30th April 2021

Re: Nucrush Quarry Blast monitoring incorrect locations
and Environmental Authority inadequacies

Attachment C2 - Map of monitored results for blast on 12th Feb 2021

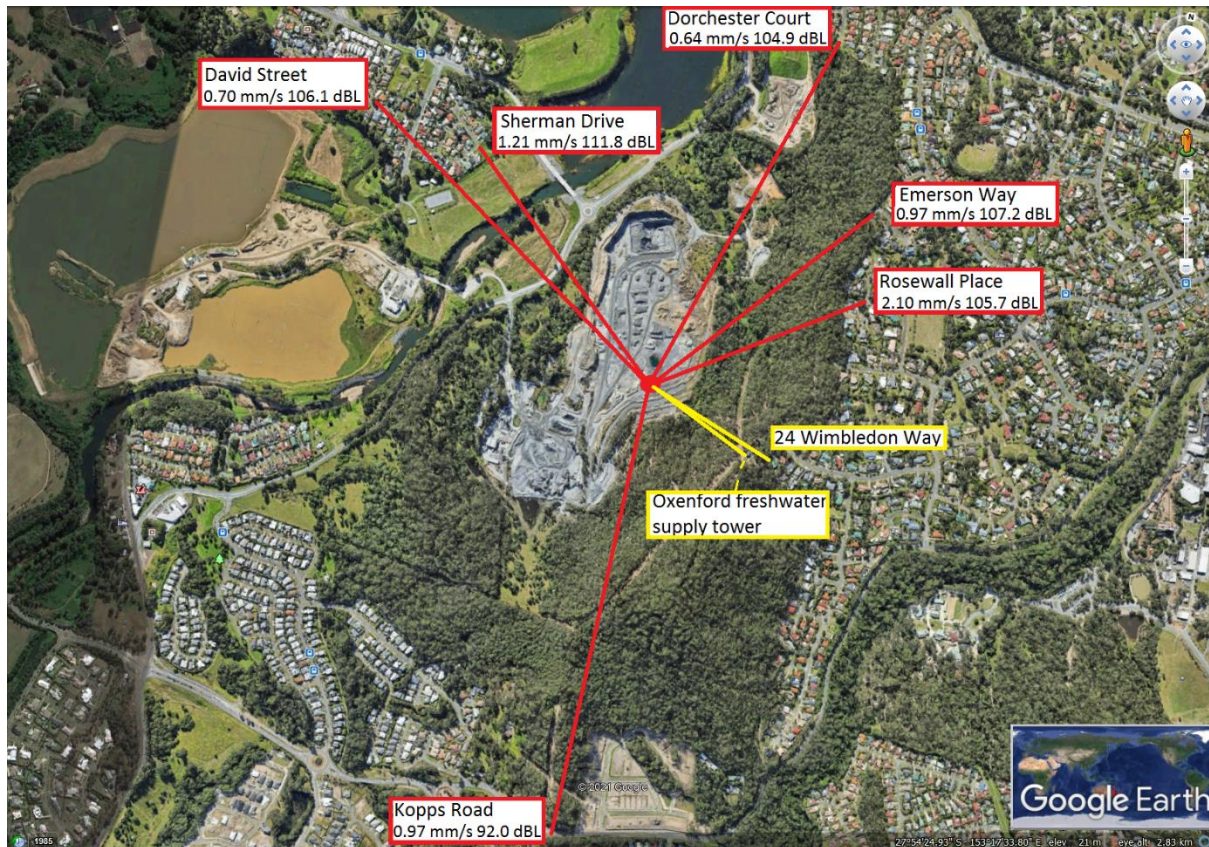
The EA requirement, as discussed earlier, is to only require monitoring at two monitoring locations. Therefore, it would seem an overkill that on the 12th February there were six monitored locations. I have plotted these monitored locations as shown in Attachment C2. It is therefore completely unbelievable that the closest sensitive receptors just the other side of the hill being blasted i.e '24

Wimbledon Way' (approximately 325 metres) and the 'Oxenford Freshwater tank' (approx. 275 metres) were not monitored. In fact, it would seem they were culpably ignored.

Using a standard ground vibration mathematical formula we can estimate the ground vibration at the nearest dwelling i.e. '24 Wimbledon Way' (as highlighted in Attachment C2):

This produces an estimated ground vibration of 5.1 mm/s at '24 Wimbledon Way' on the 12th February 2021 (based on the Kopps Road published results which are thought to be a comparable terrain and radial tangent from the blast epicentre).

Therefore, for this blast, the highest monitored ground vibration was logged at 2.1 mm/s at Rosewall Place. It is highly likely that the ground vibration witnessed at '24 Wimbledon Way' was above the 5 mm/s limit. However, the failure of both the quarry's monitoring authority and the DES failure to monitor at this more sensitive receptor means the above 5mm/s, that should have triggered the one in five consecutive blasts above the 5 mm/s limit, it would seem, went unrecorded and unchallenged.
